Access Compliance Report

Public Rights-of-Way

(Island Curb Cuts)

| Intersection ID: 18958 | Main Street: GROVER_RD | Cross Street: OLD_PINEVILLE_RD | Location: S |

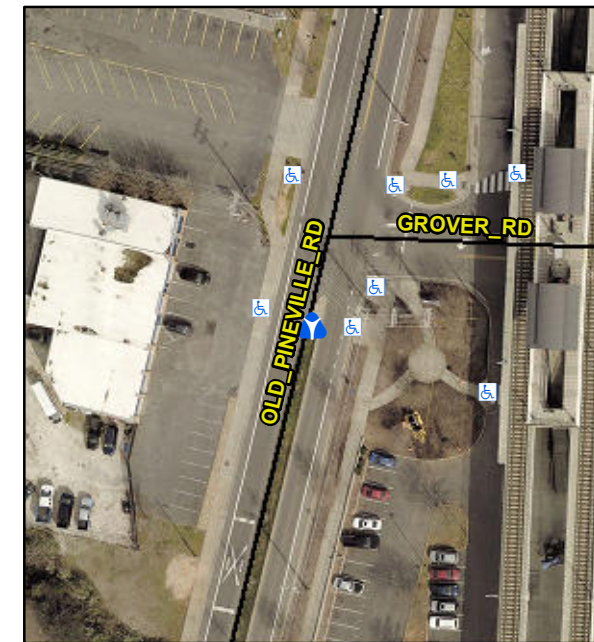
| ADA ID: E91ECDBCDDFB | Curb Cut Type: MedianRefuge2 | Initial Pass/Fail: Pass | Overall Compliance: No |

| Compliance | Description | Data | Compliance | Description | Data |
|------------|----------------------|------|------------|-----------------------------|------|
| No | Refuge 1 Length (In) | 33.0 | Yes | Gutter 1 Ponding? | No |
| N/A | Painted X Walk1? | No | No | DWS 1 Provided? | Yes |
| No | Refuge 2 Length (In) | 33.0 | Yes | Gutter 2 Ponding? | No |
| N/A | Painted X Walk2? | No | No | DWS 2 Provided? | Yes |

Remove & Replace Entire Refuge.
